2022-PW-16-1

Title: Town Hall Addition

ADDENDUM NO. 1

June 24, 2022 Total Pages: 82

REVISED DOOR SCHEDULE (REFERENCE: A2.10)

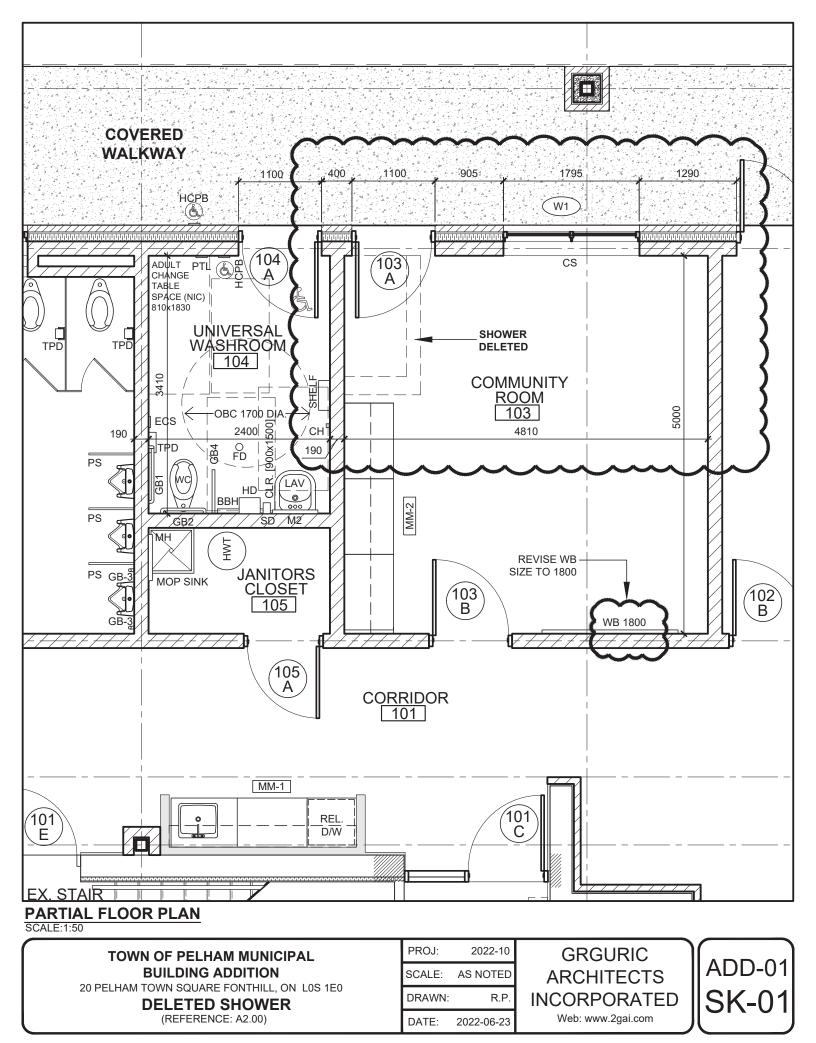
On drawing A2.00, there is a PDO (power door operator) in the universal washroom door 104A. However, door schedule on drawing A2.10 does not indicate requirement for PDO for door 104A. Please clarify

Door schedule on drawing A2.10 indicate PDO on door 103B of Community Room. However, none is indicated on partial ground floor plan on arch drawing A2.00 and electrical drawing E3.

Answer 19: Yes, power door operator required for door 104A. Refer to attached sketch ADD-01 SK-02 for revised door schedule.

Answer 20: PDO inadvertently labelled. Refer to attached sketch ADD-01 SK-02 for revised door schedule.

Refer to attached sketch ADD-01 SK-02 for revisions to door schedule.

Item 1: Refer to Hallex Electrical Sketch ES01 (Part of Drawings E1 & E4):

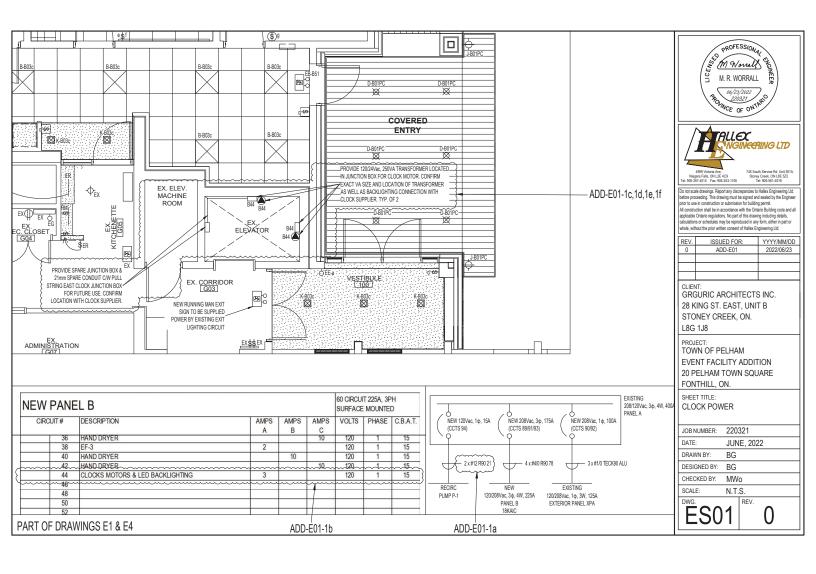
Power to be provided to specified clocks located at clock tower as per attached electrical ADDENDUM ADD-E01 issued by Hallex Engineering.

- a. Update conductor size for recirc pump P-1 on panel A as shown on sketch ES01.
- b. Add 120Vac, 1ph, 15A circuit for new clock motors & LED back lighting.
- c. Provide 120/24V transformers, mounted in junction boxes for clock motors.
- d. Clock LED back lighting to be provided with clock, this contractor to provide conductors and termination to lighting.
- e. Coordinate exact location and height of transformers/junction boxes and lighting connection with clock supplier and architect.
- f. Provide spare junction box on North side for possible future clock location. Route spare conduit c/w pull string between this spare junction box and East side transformer junction box.

Item 1: Reference to Hallex Mechanical Drawing P1.1, Rev 3:

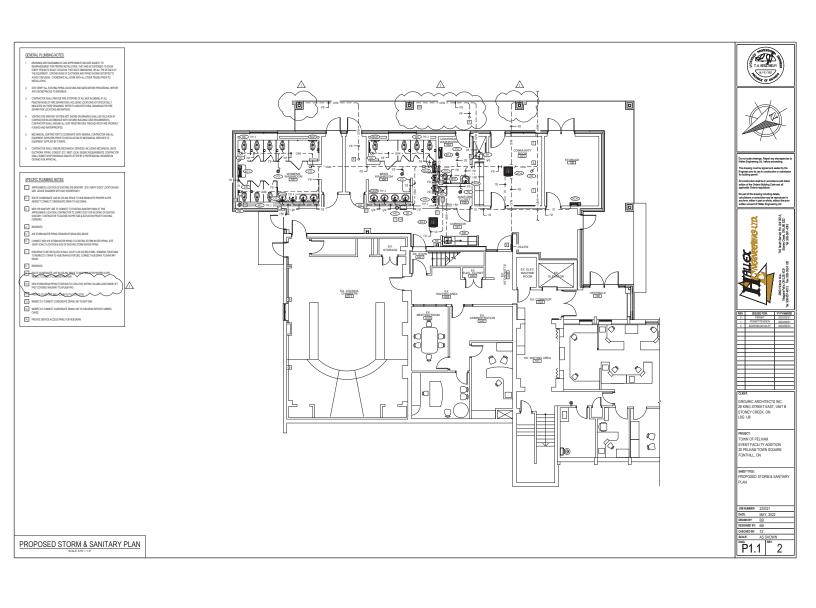
Refer to attached mechanical addendum MA-01 for revised locations of rainwater leaders and storm piping routing.

- 1. Roof Storm Piping Routing
 - a. Storm piping for new roof routing adjusted to run within columns to low level.
